**PLANNING DIRECTOR'S SPECIAL PERMIT
FOR SINGLE FAMILY RESIDENTIAL IN A PUD**

FILE: P99-019

PROJECT NAME: Gateway West PUD - Portions of Villages 1 & 2

WIDE LOT SERIES - PLAN 1

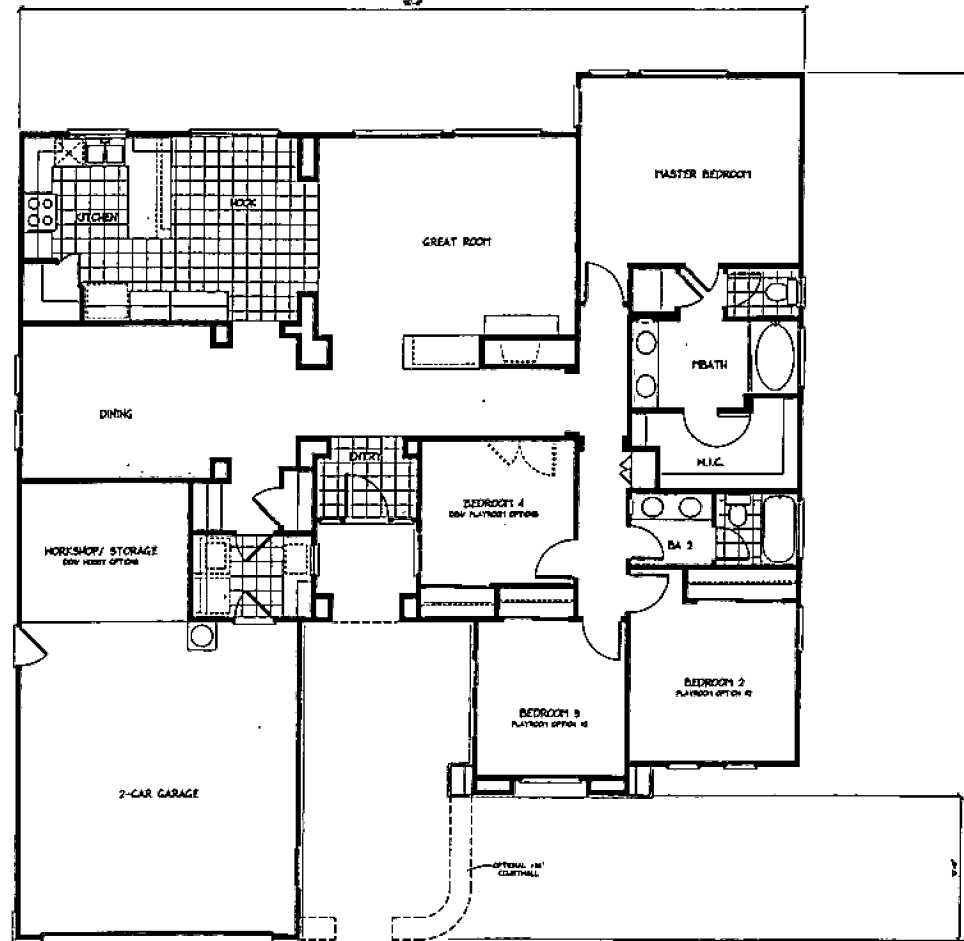
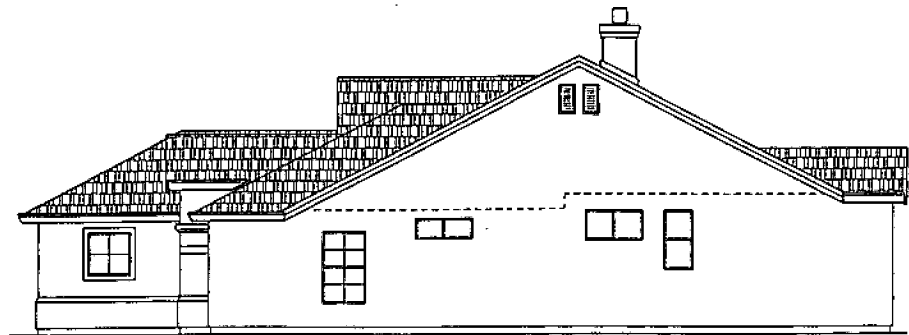
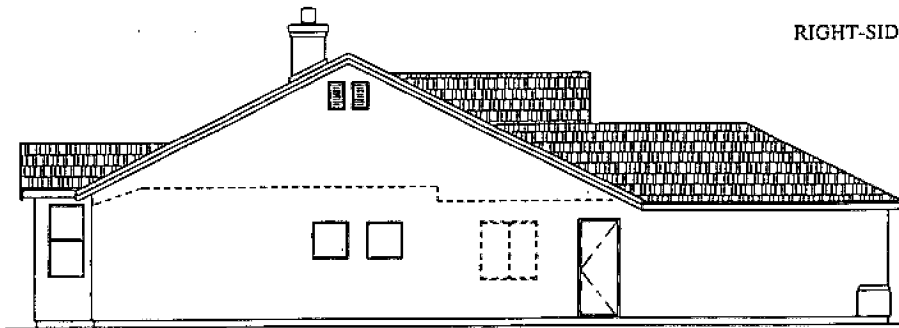
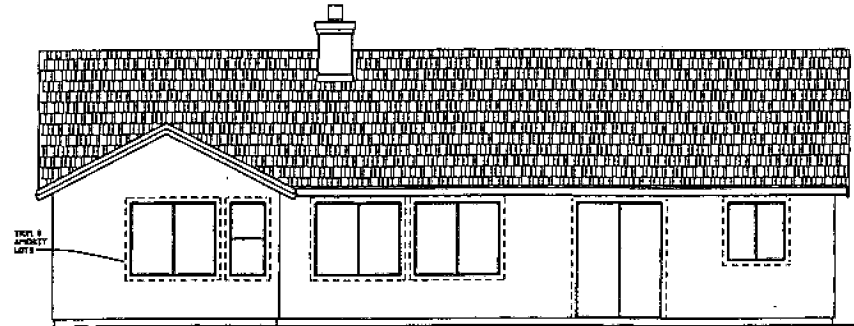
18. Model homes: Plan 1 shall be built with the optional front courtyard wall. This model shall include French doors from Bedroom #3 opening into the courtyard area. By showing both of

these options on the model home, the use of these design features may encourage greater buyer acceptance. The two options may be marketed separately.

Plan 2010: Substantially approved. The GWDRC will require courtyards on all these elevations. See additional comments below.

WIDE LOT SERIES - PLAN 2

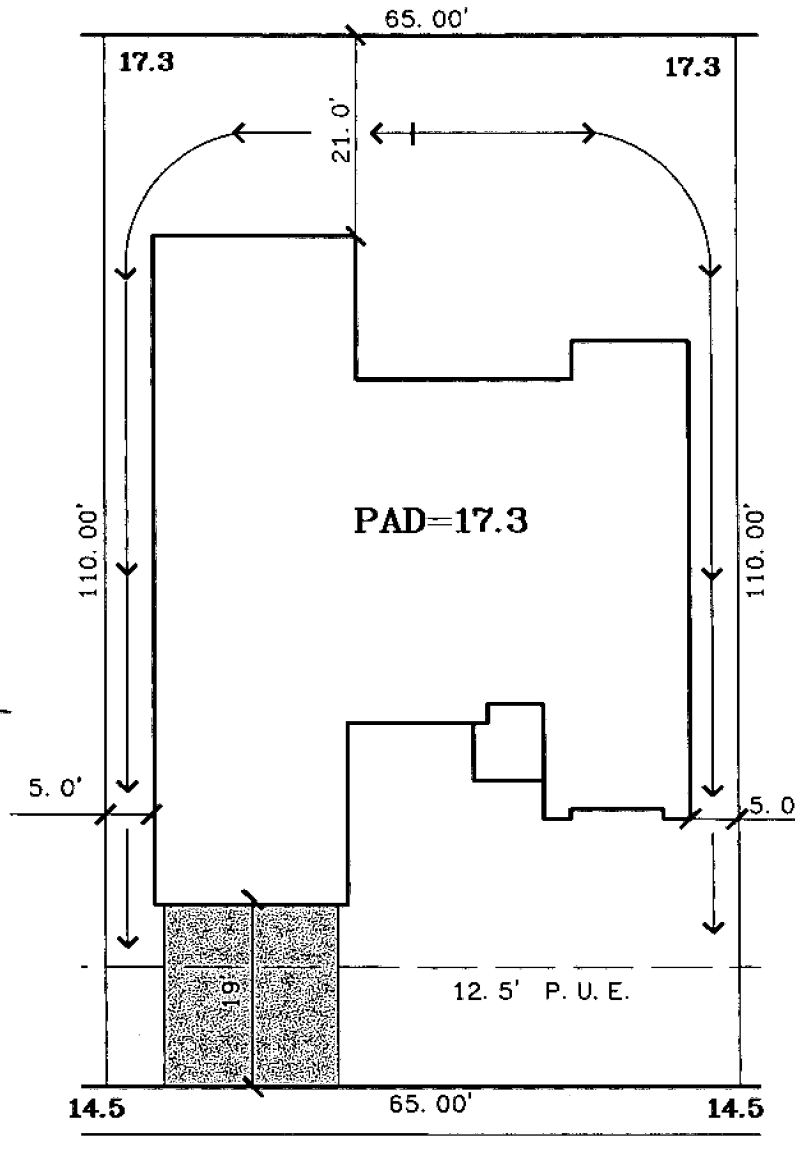
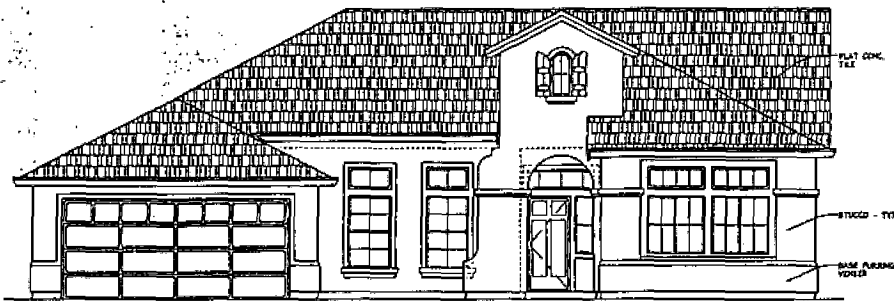
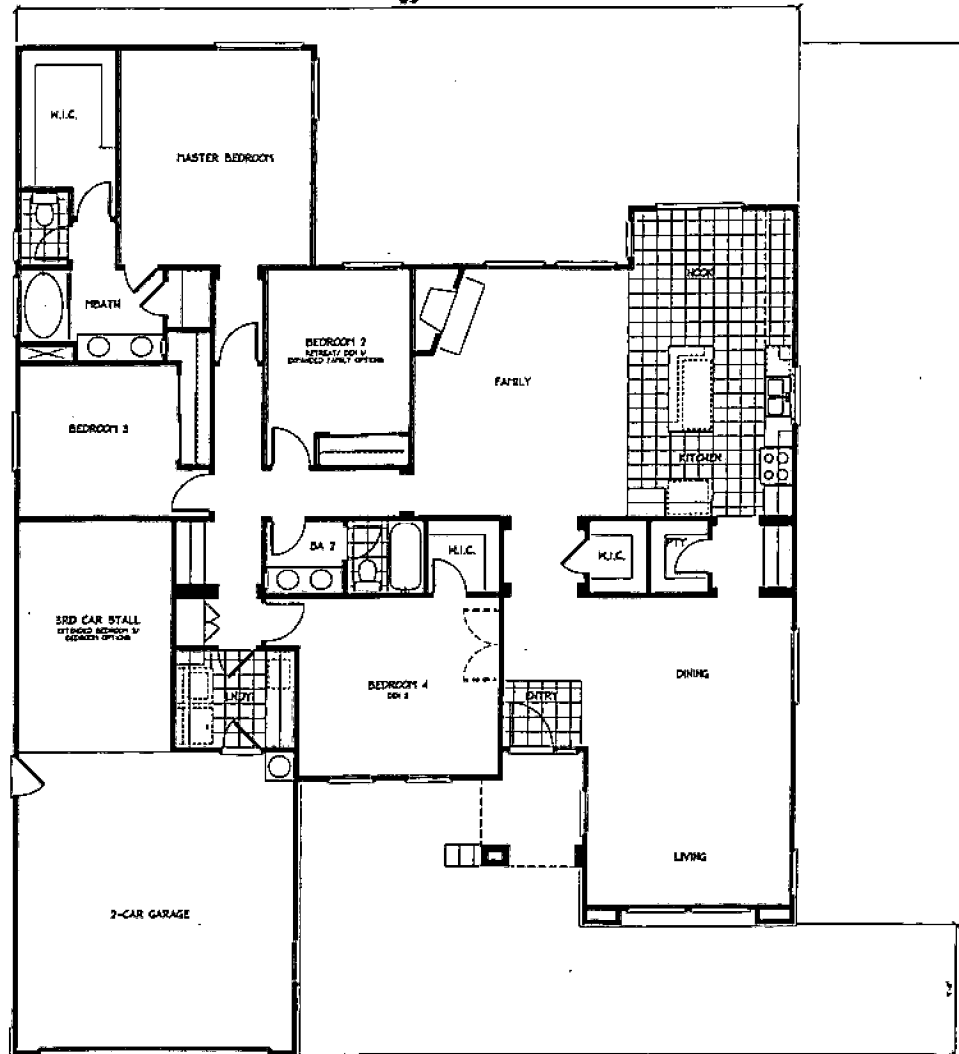
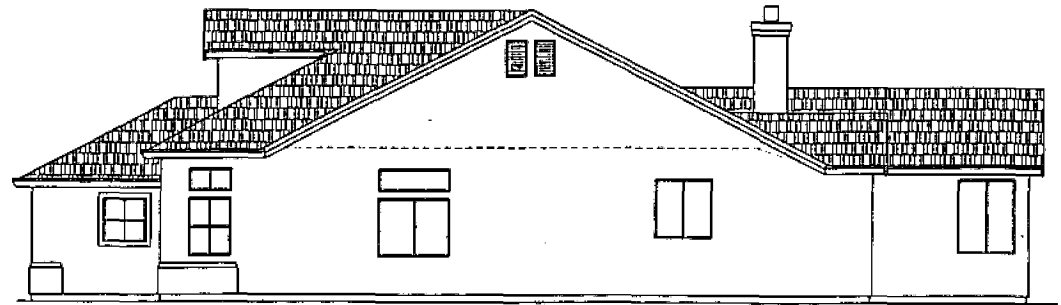
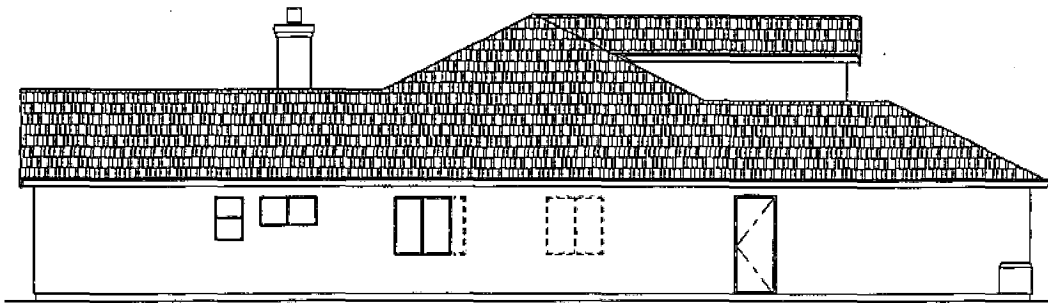
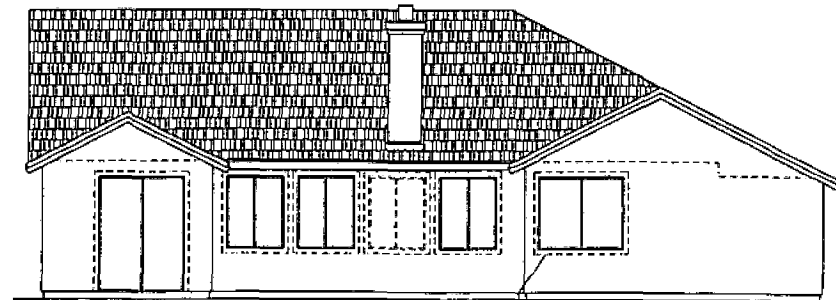
Plan 2256: Approved as submitted. See additional comments below.

DOCK DIAGRAM
GATEWAY WEST COMMUNITY

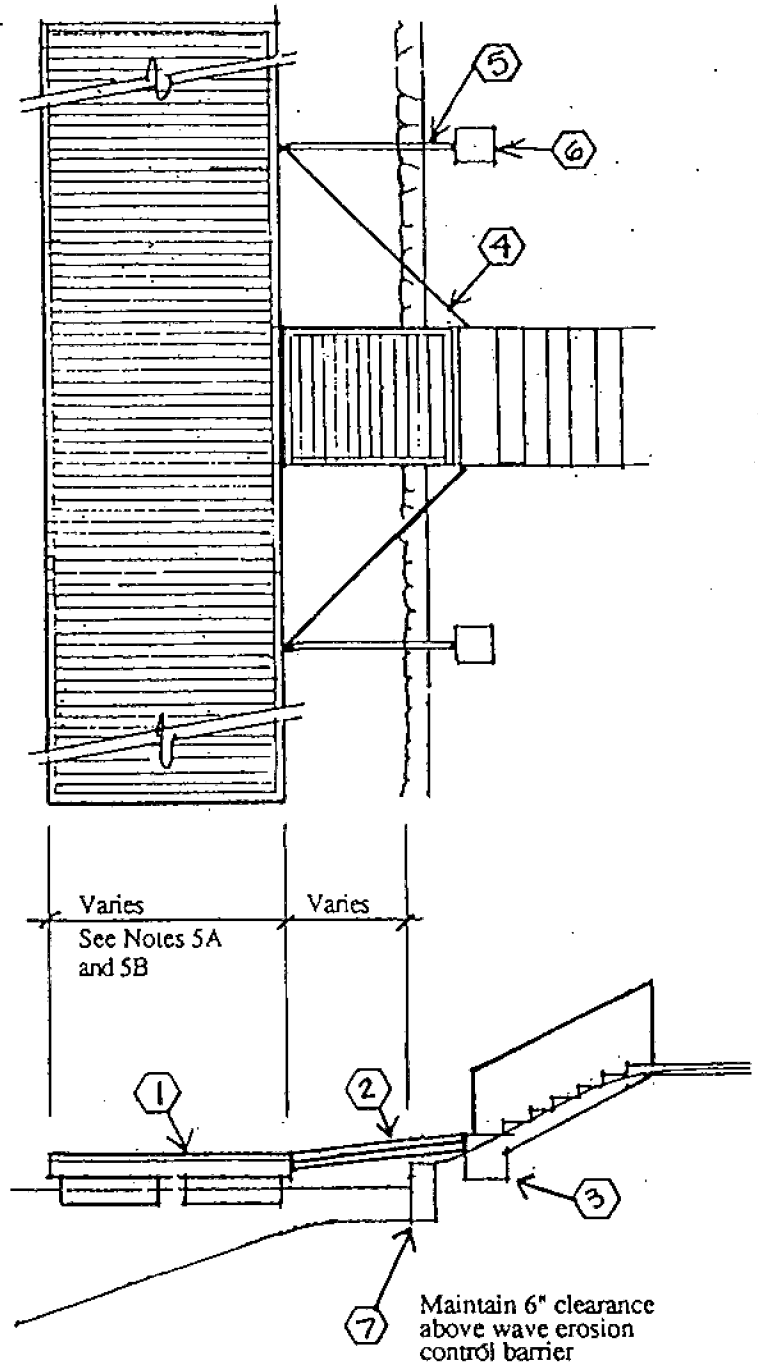
17. Docks shall be permitted as shown in Exhibit 7. If alternative building materials are proposed to be used, i.e., PVC, the applicant shall provide the applicable ICBO Report(s) to the Chief Building Official at the time of submittal of the dock plans. The Building Official may require other suitable technical information in lieu of an ICBO Report. The installation of all docks shall also be subject to the approval of the Department of Utilities.
